Service Bulletin

Subject: Side Blind Zone is Not Working Correctly and/or Incorrect Side Mirror Notification

Brand:	Model:	Model Year:		VIN:		Engine:	Transmission:
		from	to	from	to		
Chevrolet	Bolt EV	2017	2017				
Opel	Ampera-e	2017	2017

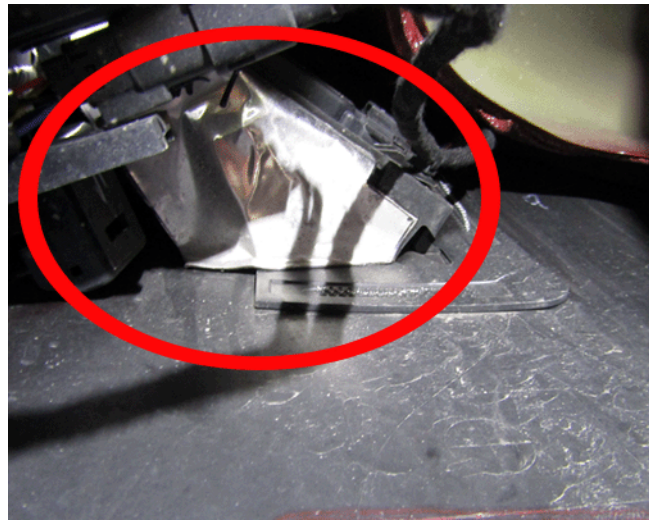
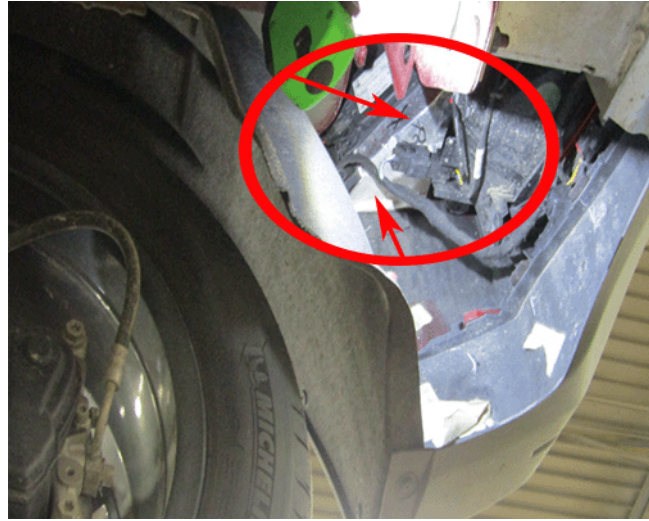
Involved Region or Country	North America, Europe
Additional Options (RPOs)	Equipped with Side Active Safety Obstacle Detection Enhanced (RPO UKC)
Condition	Some customers may comment when driving, the side mirror indicates there is a vehicle present when there actually is not. This condition may be experienced after rear fascia replacement.
Cause	This condition may be due to the object sensing alert module missing the single piece of aluminum butyl tape that is located on the bottom of both left and right module bracket.

Install a new single piece of aluminum butyl tape on the bottom of the object sensing alert module brackets.

1. Raise the vehicle to its full height. Refer to *Lifting and Jacking the Vehicle* in SI.
2. Using Acrysol or equivalent, clean the bottom of the module and allow to dry.
3. Peel the backing off of the aluminum butyl tape and apply to the bottom of the module.
